BEN EIELSON JR./SR. HIGH SCHOOL – PHASE 3
EIELSON AIR FORCE BASE, ALASKA

LIGHTING FLOOR PLAN

DRAWING NUMBER
29-02-38

1 / E2.2 **PARTIAL AREAS 'D' 'C' & 'B' LIGHTING FLOOR PLAN**

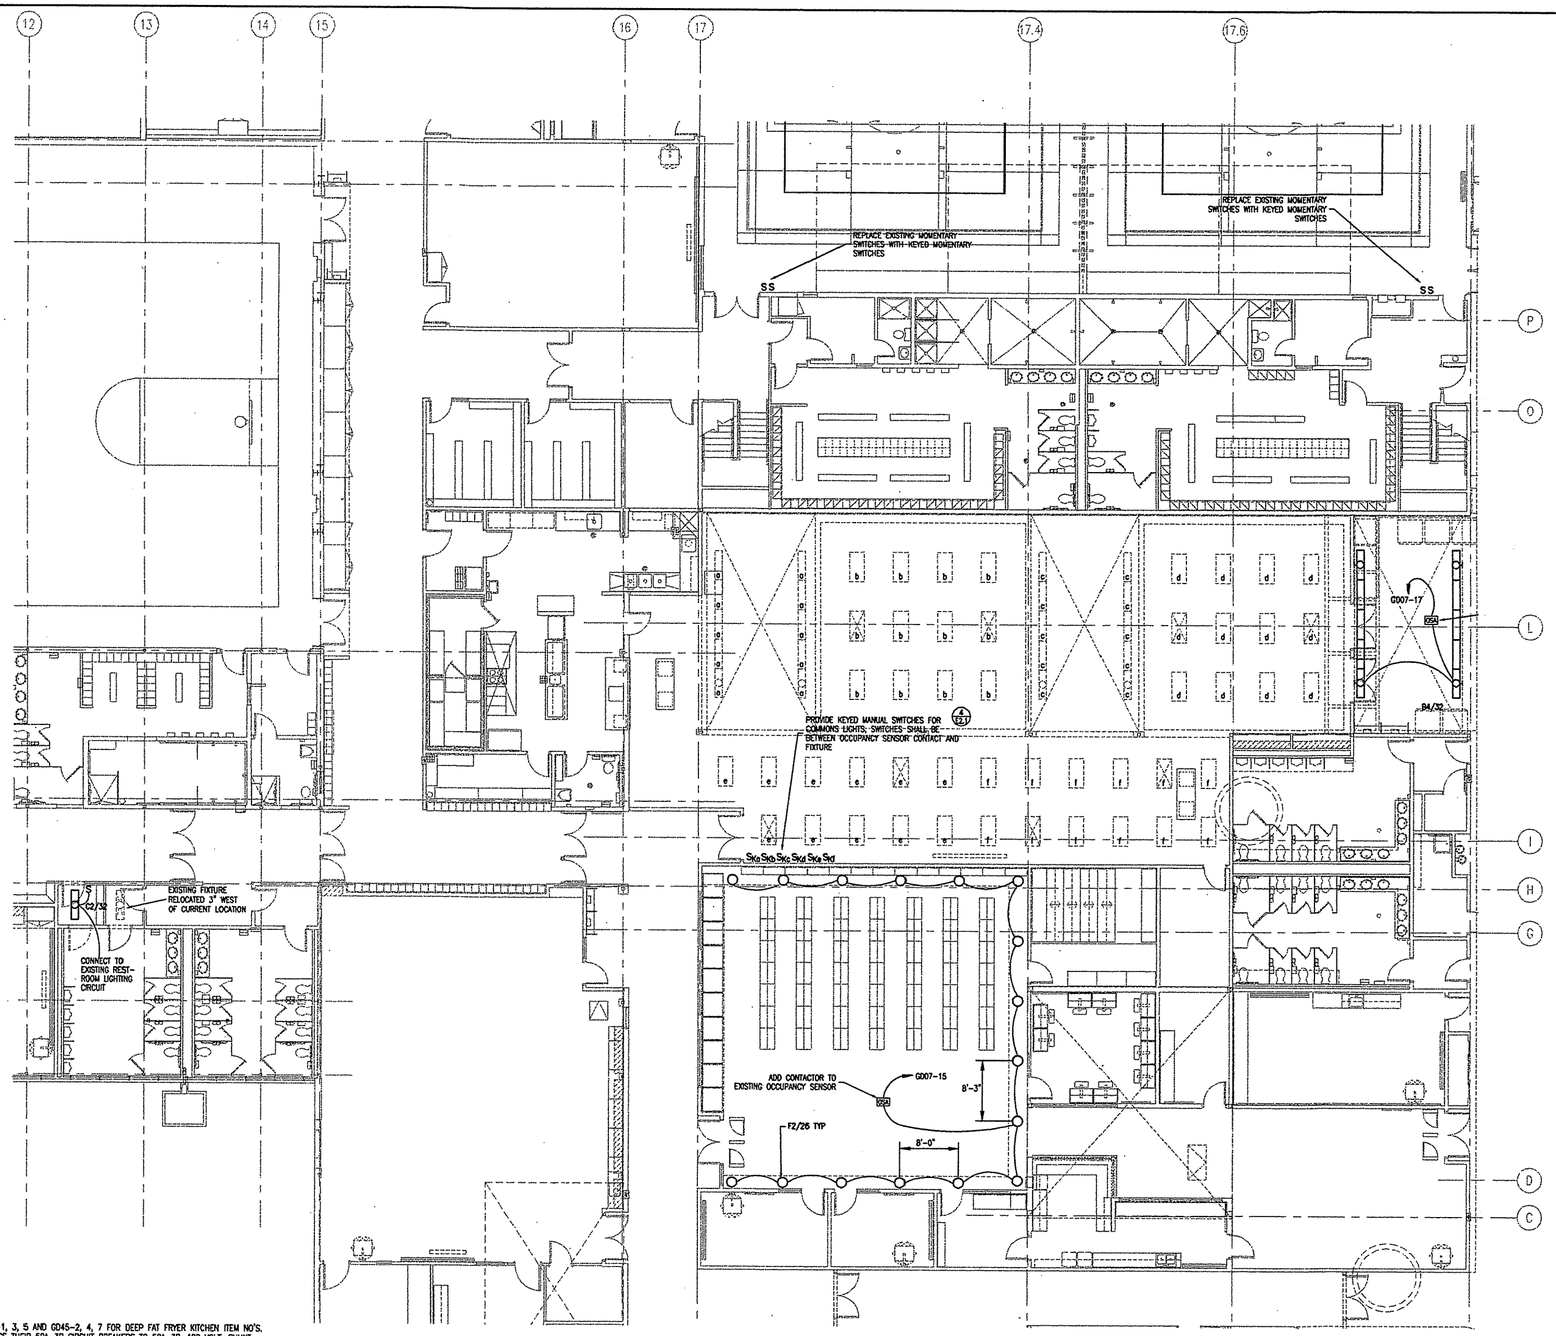
1. FOR CIRCUITS GD45-1, 3, 5 AND GD45-2, 4, 7 FOR DEEP FAT FRYER KITCHEN ITEM NO'S. 17a AND 17b, CHANGE THEIR 50A-3P CIRCUIT BREAKERS TO 50A-3P, 120 VOLT, SHUNT TRIP CIRCUIT BREAKERS.

WIRE SHUNT TRIP TO OPEN CIRCUIT BREAKER IF HOOD EXTINGUISHING IS ACTIVATED OR IF DEEP FAT FRYER HIGH TEMPERATURE CONTROL LIMIT IS EXCEEDED.

2. FOR CIRCUIT GD-43-27 AND 29, FOR HOT PLATE RANGE KITCHEN ITEM NO. 15, CHANGE ITS 30A-2P CIRCUIT BREAKER TO A 30A-2P, 120 VOLT, SHUNT TRIP CIRCUIT BREAKER.

WIRE SHUNT TRIP TO OPEN CIRCUIT BREAKER IF HOOD EXTINGUISHING SYSTEM IS ACTIVATED.

3. OBTAIN SHUNT TRIP CONTROL VOLTAGE FROM SPARE CIRCUIT GD26, IF NOT AVAILABLE AT HOOD EXTINGUISHING SYSTEM OR FRYER CONTROL PANEL.
